# DOWNTOWN DESIGN REVIEW BOARD

RECOMMENDATION BOOKLET

# 600 WALL STREET

SEATTLE, WASHINGTON | DPD# 3015251 | JANUARY 06, 2015

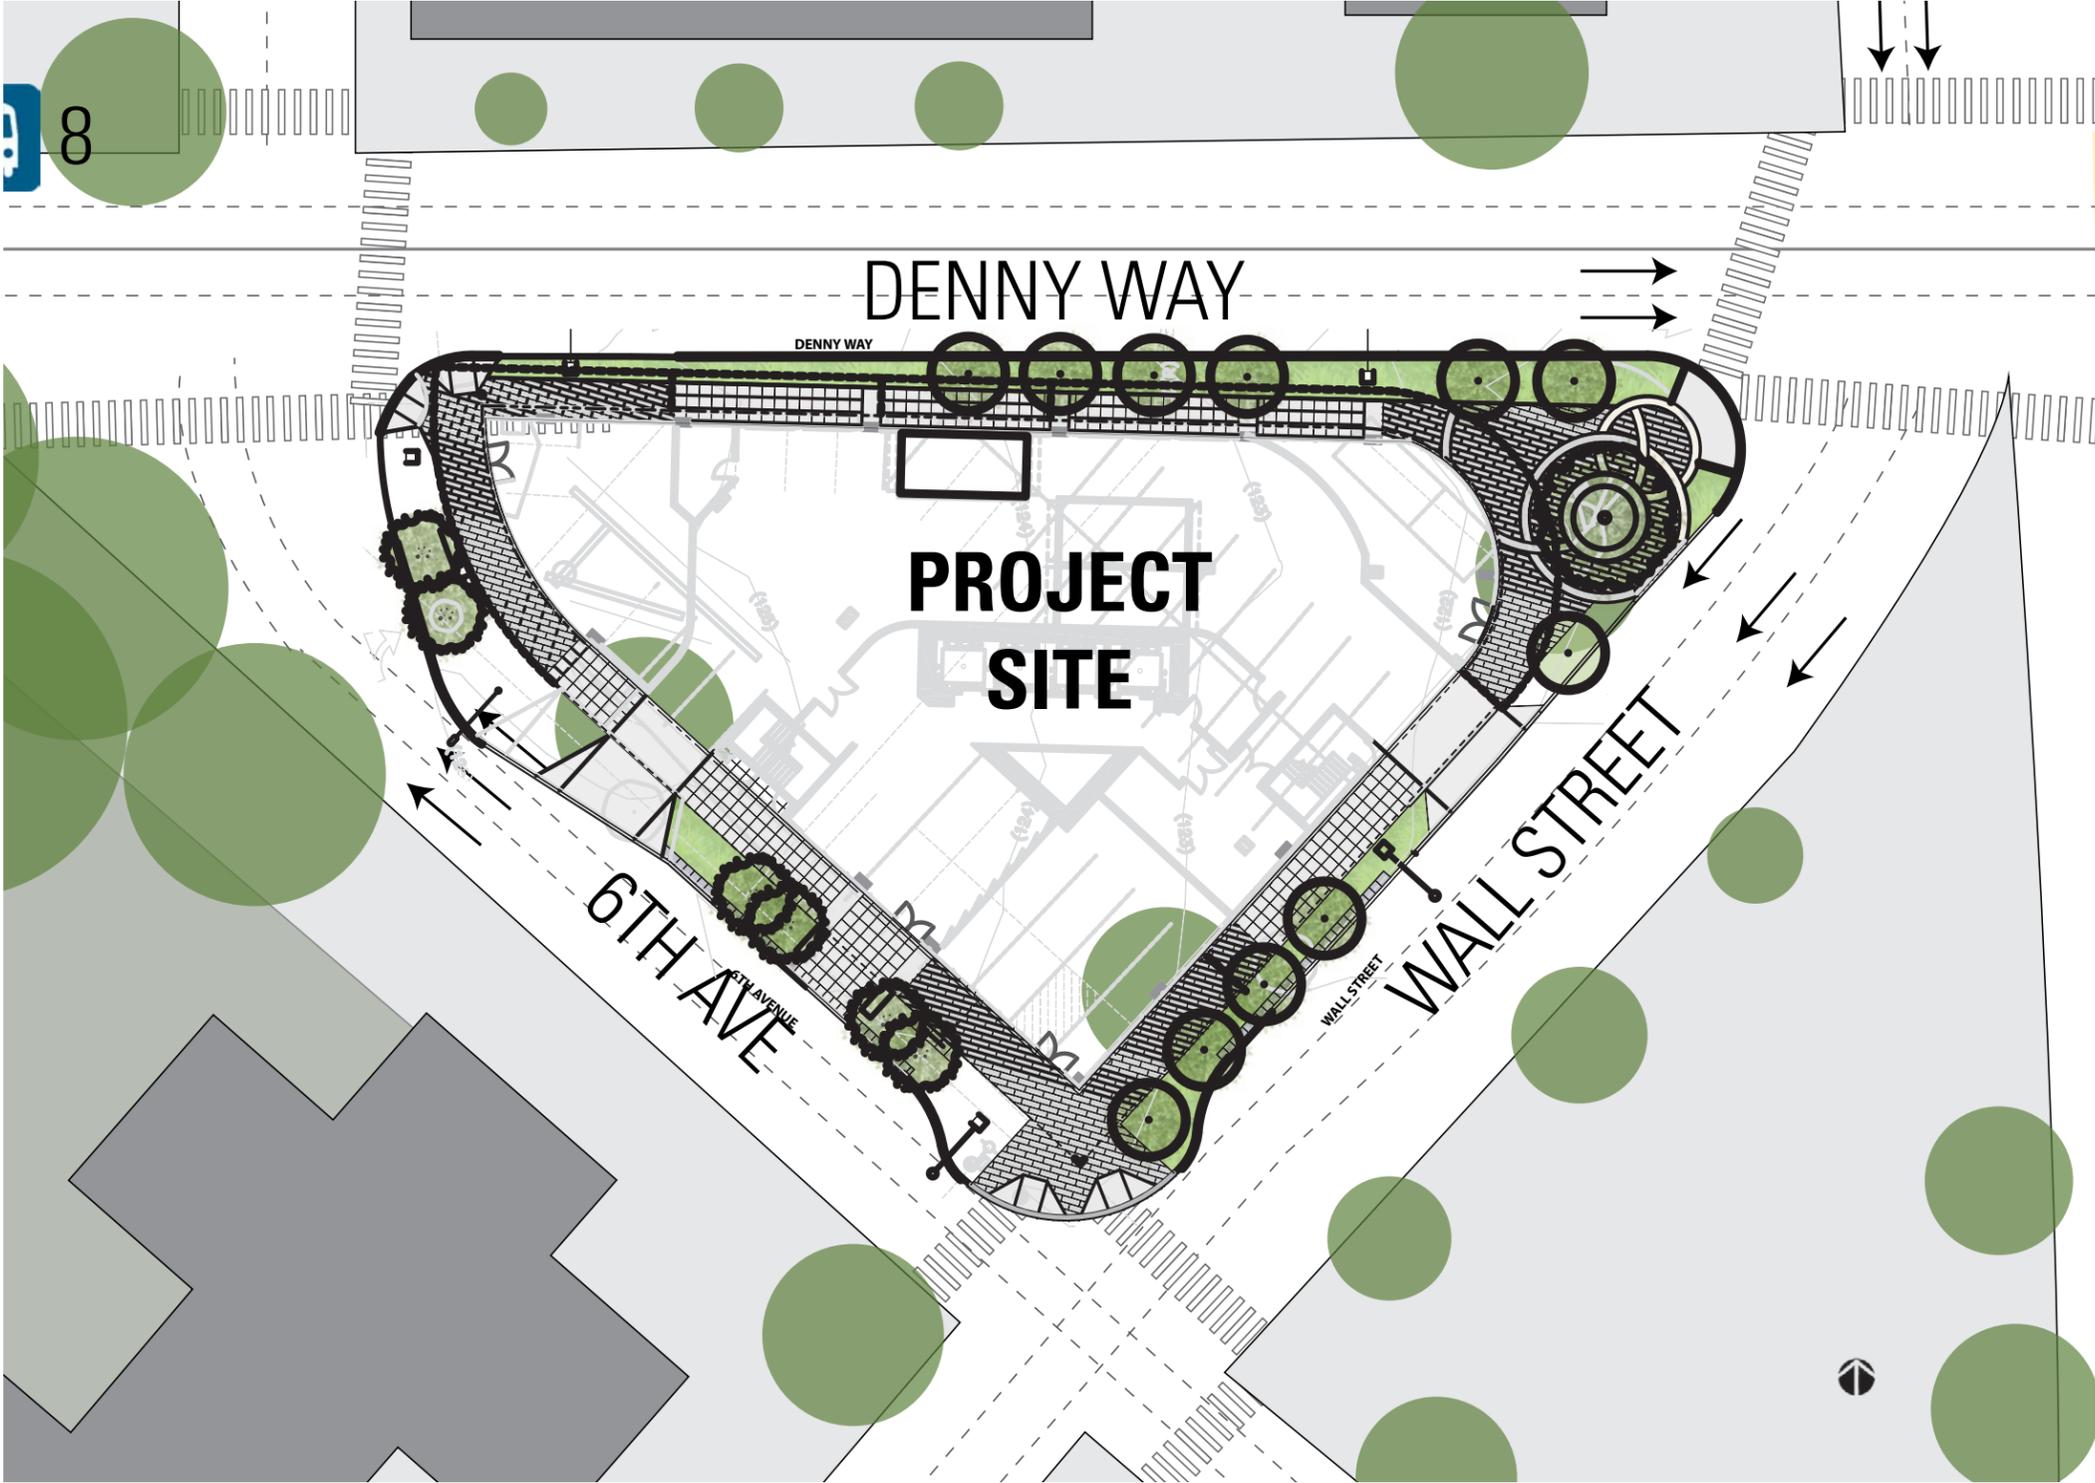
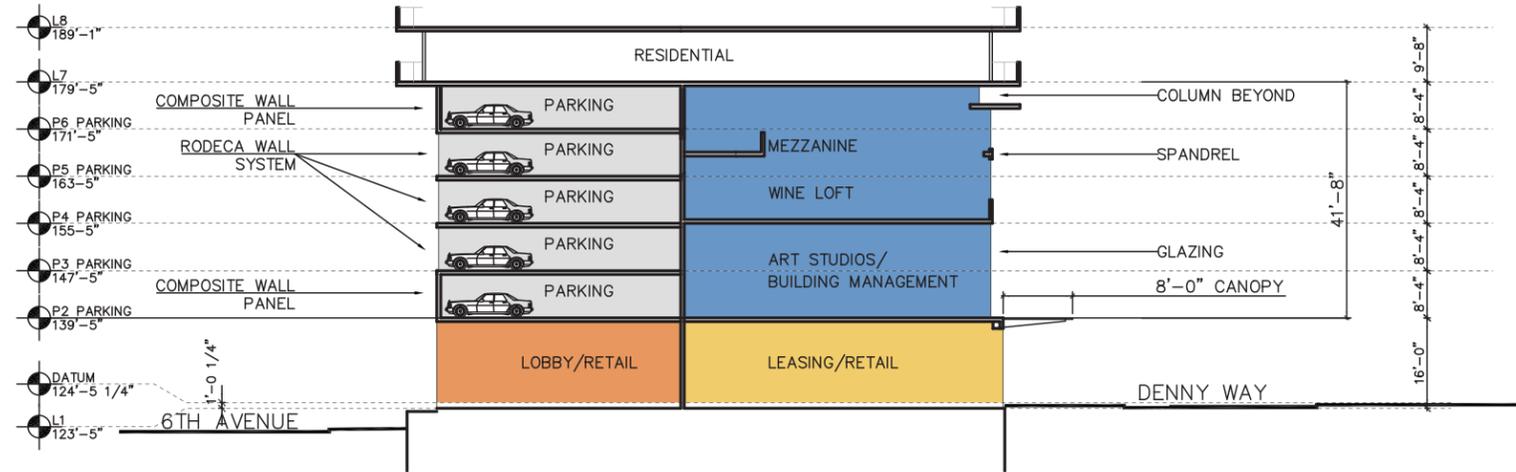
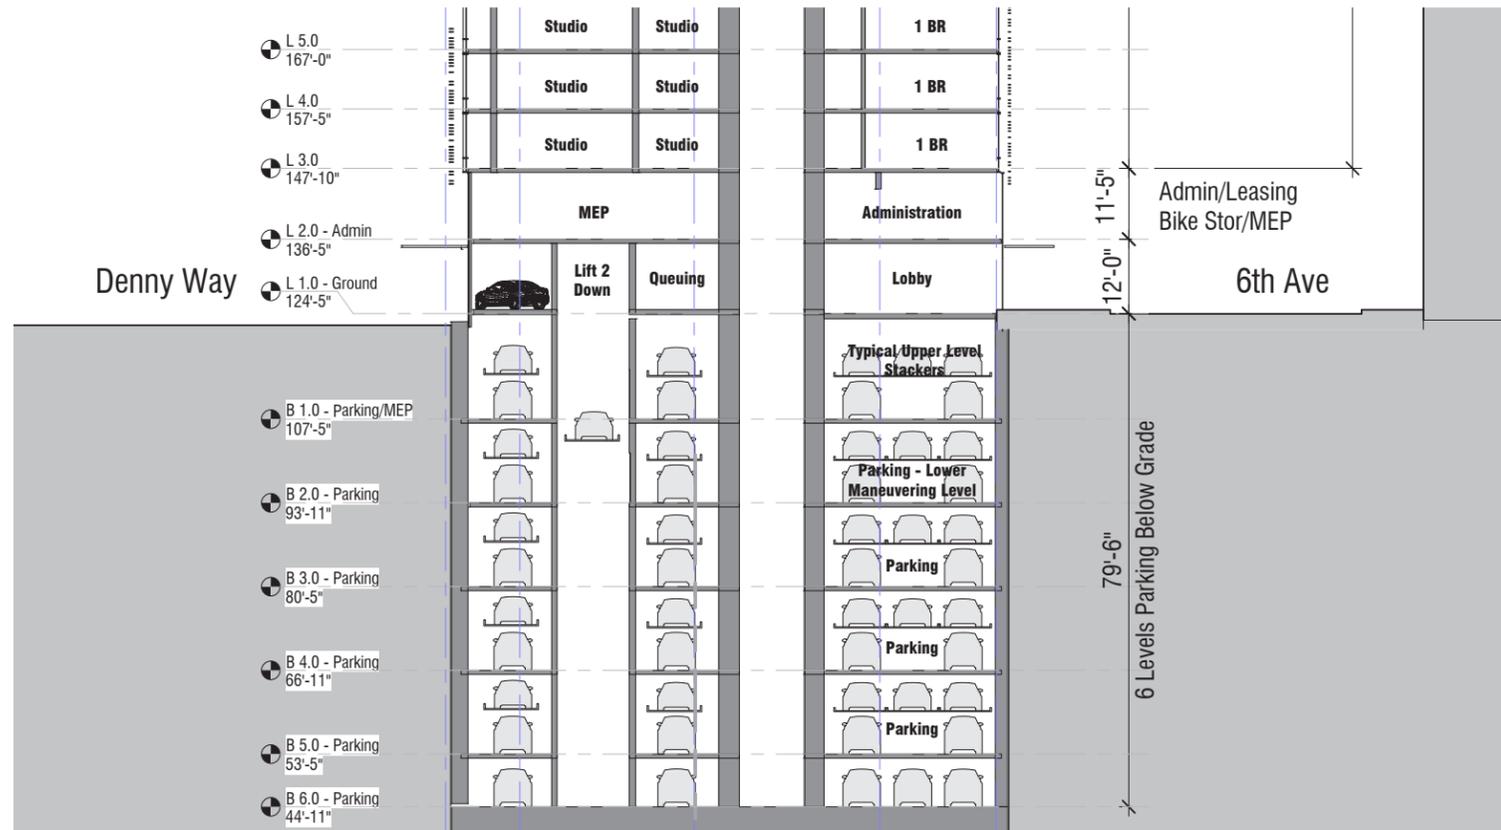
At the Early Design Guidance Meeting #2, the Board applauded the revisions that added depth and area to the ground floor commercial spaces, and the shifted transformer hatch. To further improve this now viable layout, the Board advised the following to best activate this critical location:

- Increase the depth of the retail at 6th and Wall to the structural bay (about 23 ft).
- Shift the leasing space along Denny to an upper level and replace it with a retail/commercial space at grade.
- To enlarge the corner areas, explore shifting the two exit stairs along Denny as far mid-block as possible (and keep them glass at grade as stated).
- At next meeting, provide a larger scale, full page ground floor plan that clearly shows all perimeter doors, solid and transparent wall changes, reveals and plane changes, and any stepped floor slabs (Board supported to eliminate steps to sidewalks). Plan should be consistent with perspectives and all elevations, in particular round versus square columns, vehicle lifts, loading doors, etc.

- Redesign of the street level floor has resulted in larger and more functional commercial spaces at street level and at all corners.
- Retail space has been added at the corner of Wall St and 6th Ave. with the primary frontage on Wall. The commercial space will be designed to open into the residential lobby so that the lobby will be further activated as a semipublic space.
- The building storefront is set back 2' from the property line resulting in a 7' wide sidewalk along Denny Way.

All of the above grade parking has been relocated to below grade parking levels. The parking on level 2 has been replaced with leasing/administrative offices, mechanical/ electrical equipment rooms and bike storage.

Levels 3, 4 and 5 parking has been replaced with residential uses. This change brings the more active uses closer to the street level.

LEVEL 1  
GROUND

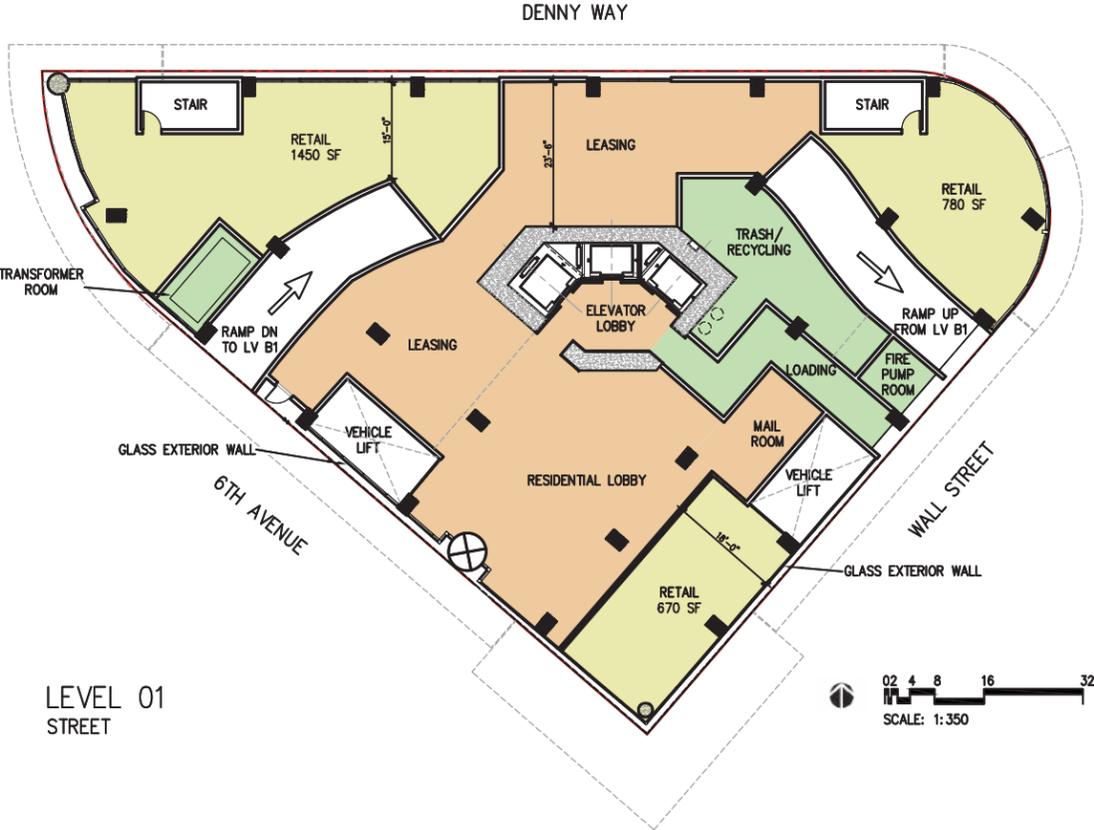
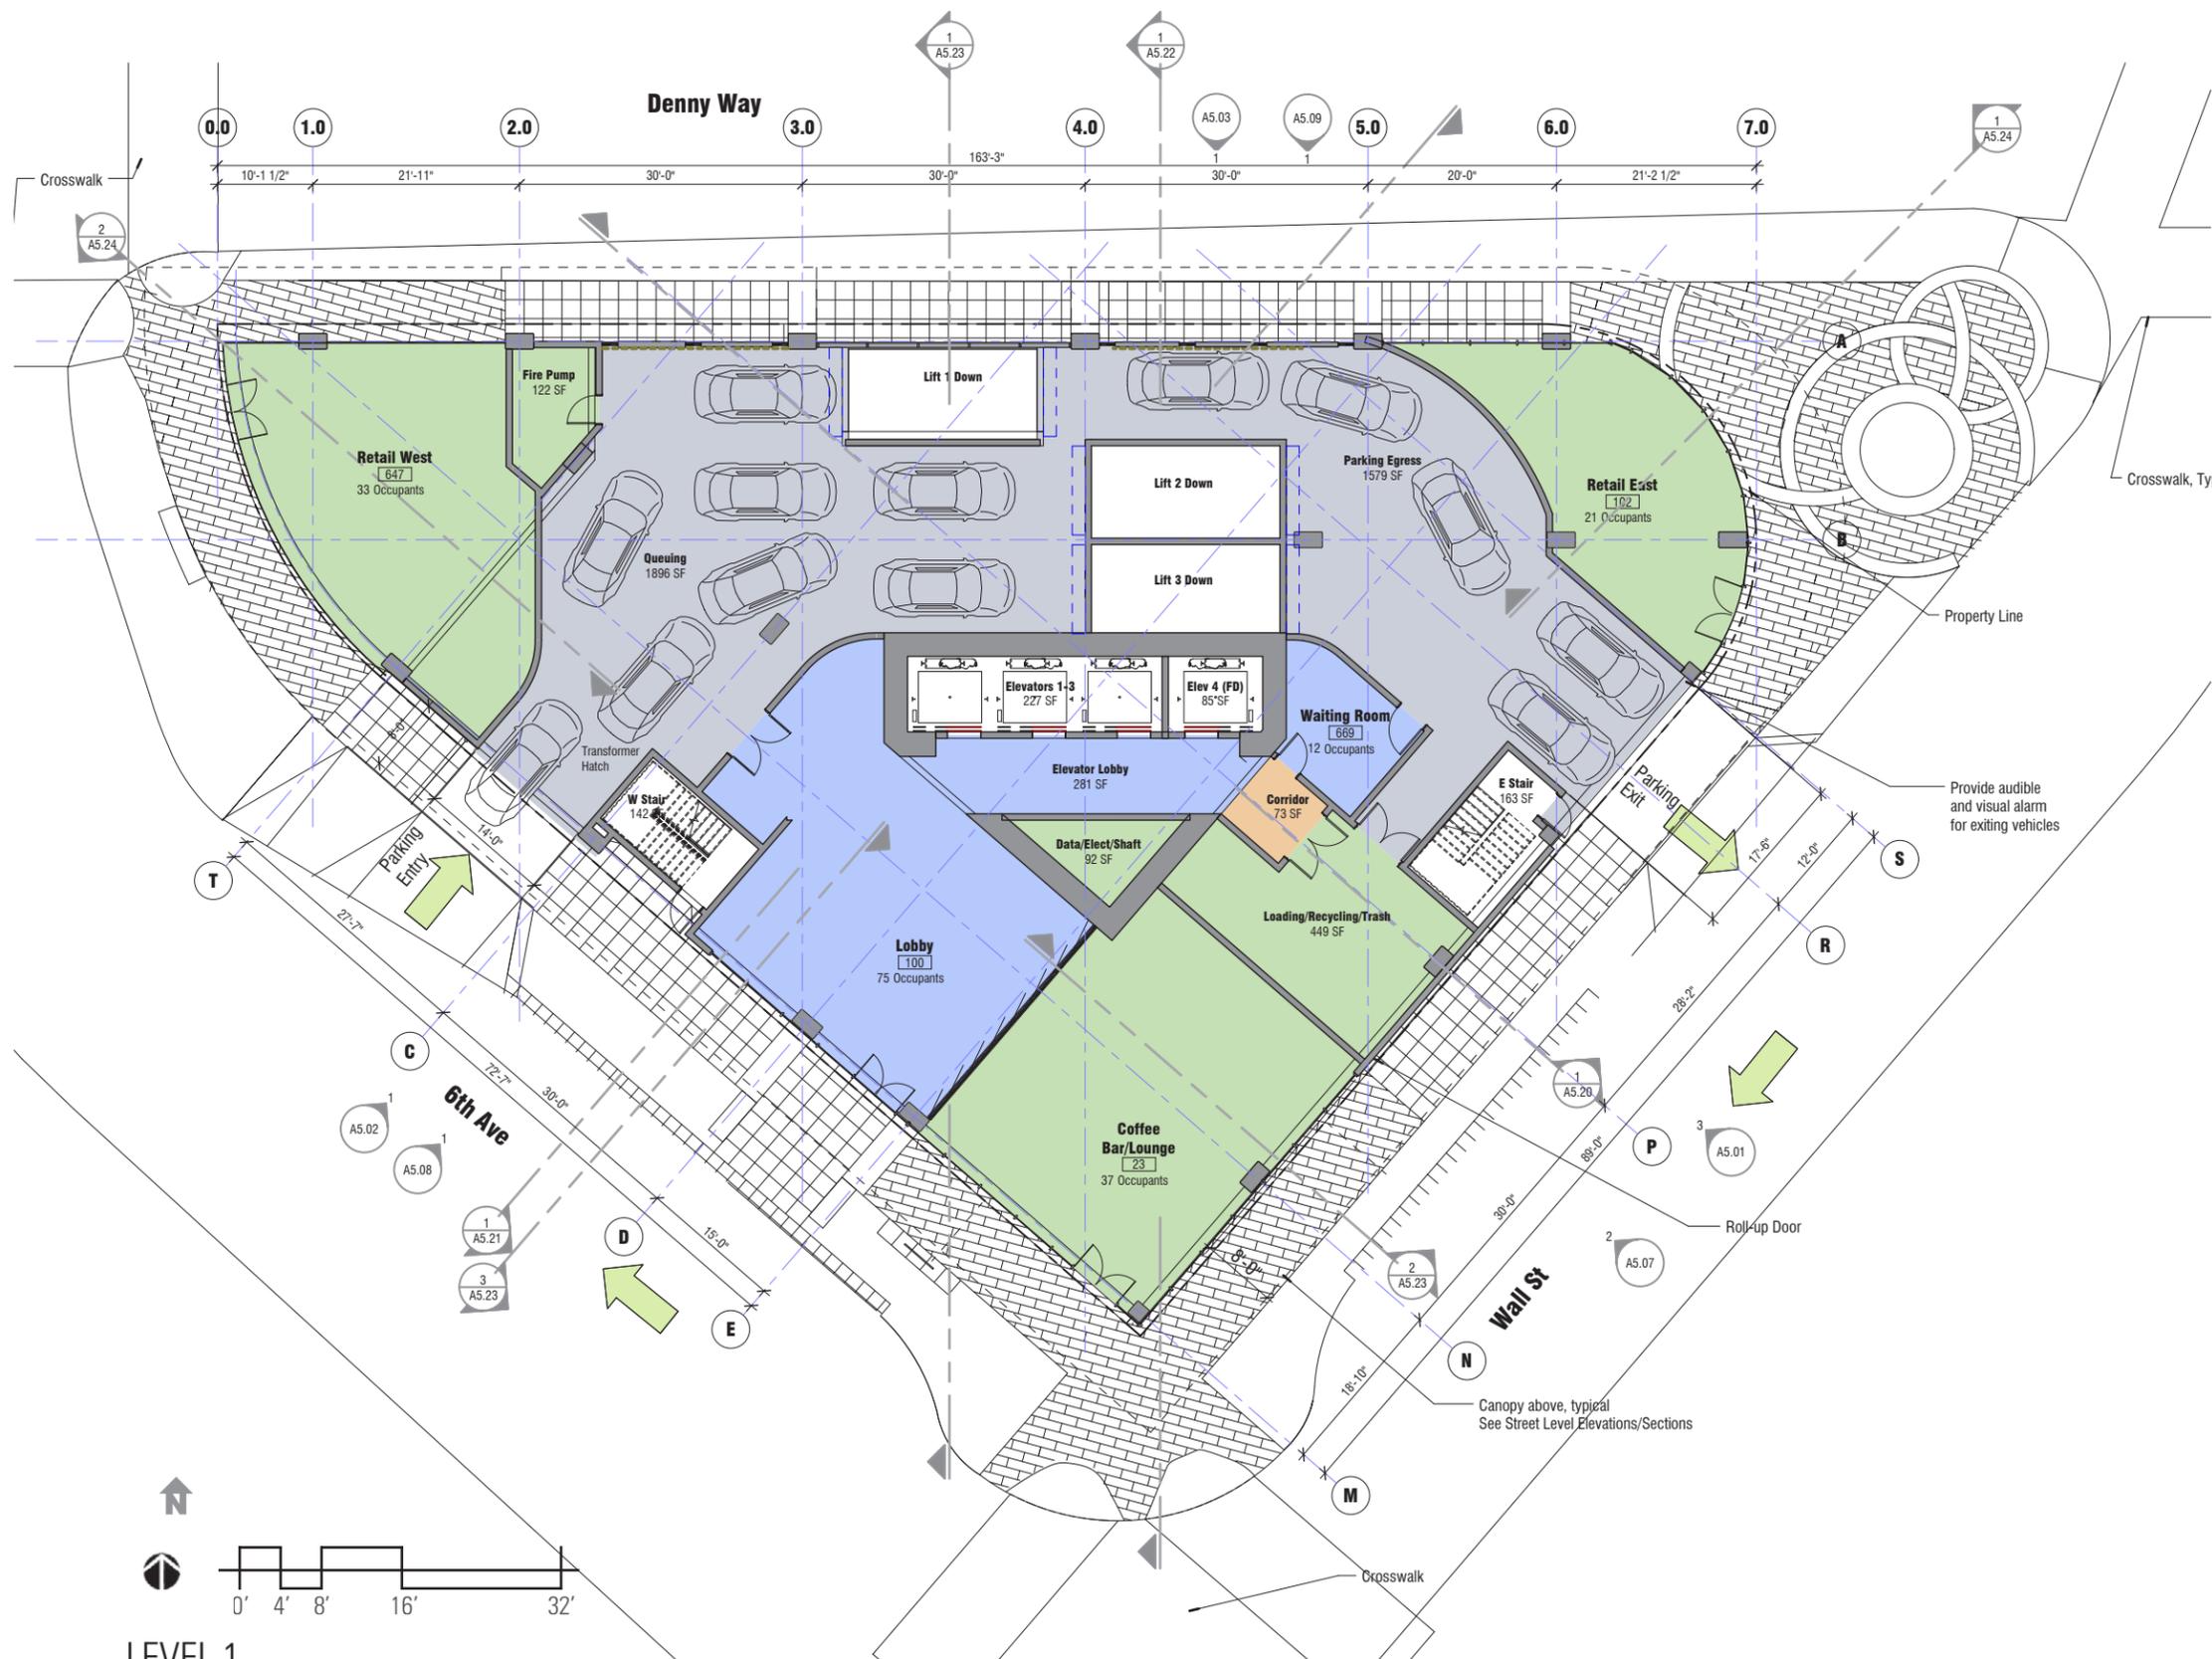
At the Early Design Guidance Meeting #2, the Board applauded the ramp sections which maximized the retail floor area, supported the ramp locations and the portal opening sizes. They requested detailed material descriptions of how these ramp walls and ceilings will be treated, since they will be visible to pedestrians down to level P-1.

- Vehicular ramps have been eliminated - drive in areas will have textured paving, and finished walls and ceilings - similar to a hotel porte cochere.
